SUBJECT: **NEW VEHICLE DEMONSTRATION / DELIVERY HOLD
 Compliance Recall 21C24**
 Certain 2020-2021 Model Year Ranger Super Cab Vehicles
 Rear Seat Child Restraint Anchorage System

NEW VEHICLE DEMONSTRATION / DELIVERY HOLD
Compliance Recall 21C24
Certain 2020-2021 Model Year Ranger Super Cab Vehicles
Rear Seat Child Restraint Anchorage System

CERTAIN 2021 MODEL YEAR RANGER SUPER CAB VEHICLES — CHILD RESTRAINT ANCHOR

FIGURE 2

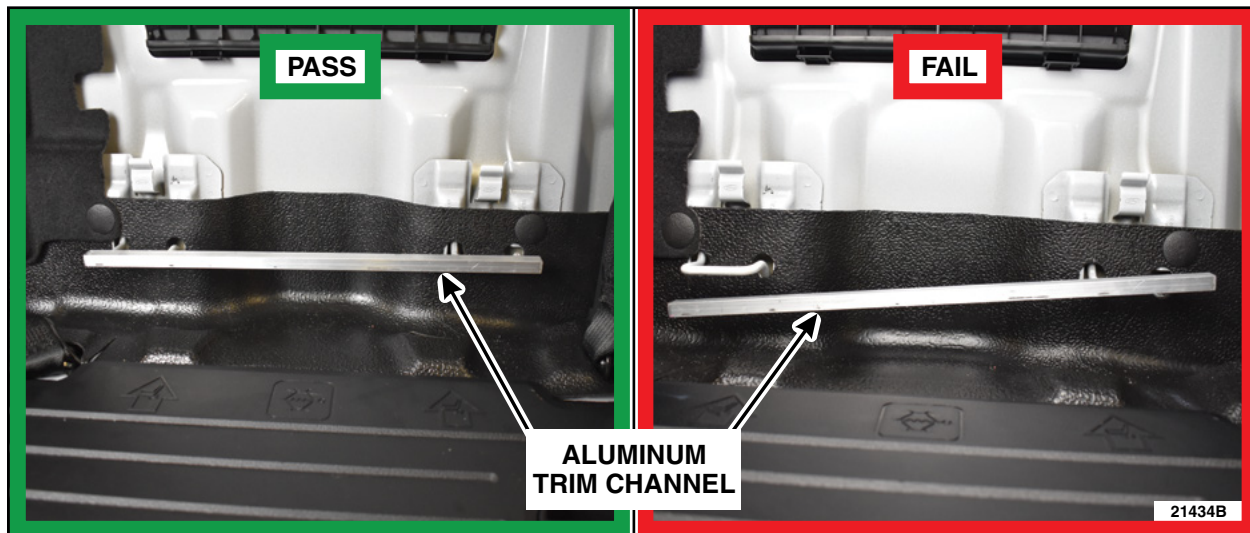
2. Remove both the Right Hand (RH) and the Left Hand (LH) rear seat cushions. Please follow the Workshop Manual (WSM) procedures in Section 501-10B.
3. On both sides of the vehicle, place the 1/4 inch (6.35 mm) aluminum trim channel over the child restraint anchors. If the aluminum trim channel fits over both of the child restraint anchors that side of the vehicle is considered a pass. See Figure 2. Did either rear RH or LH child restraint anchors fail?

Yes - Proceed to Step 4.
No - Proceed to Step 8.

FIGURE 4

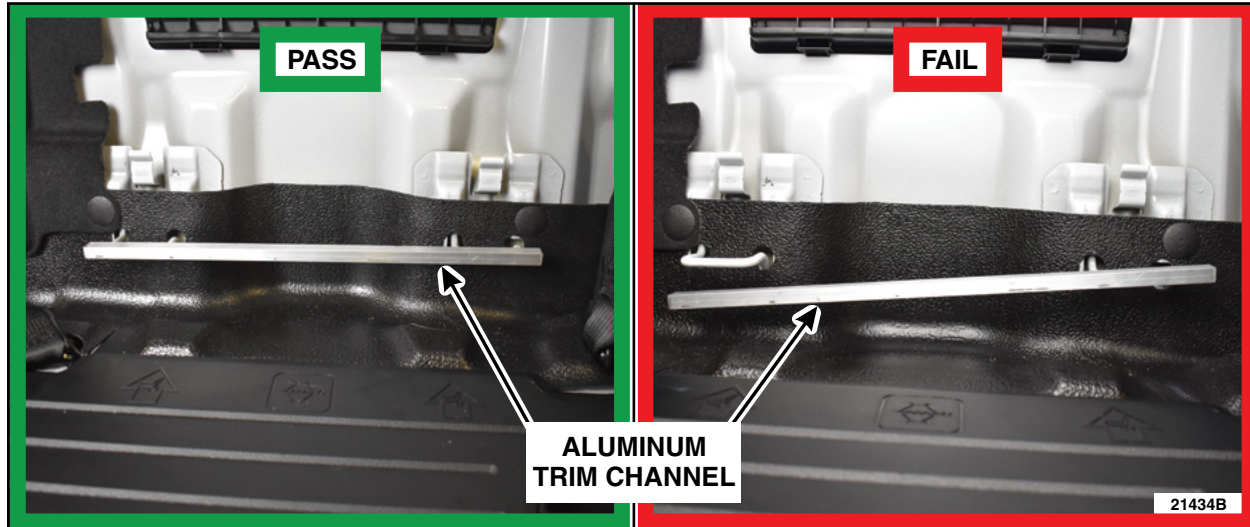
6. Place the 1/4 inch (6.35 mm) aluminum trim channel over the adjusted child restraint anchor(s). Does the affected child restraint anchor(s) fit within the aluminum trim channel? See Figure 4.

Yes - Proceed to Step 7.

No - Proceed to Step 5.
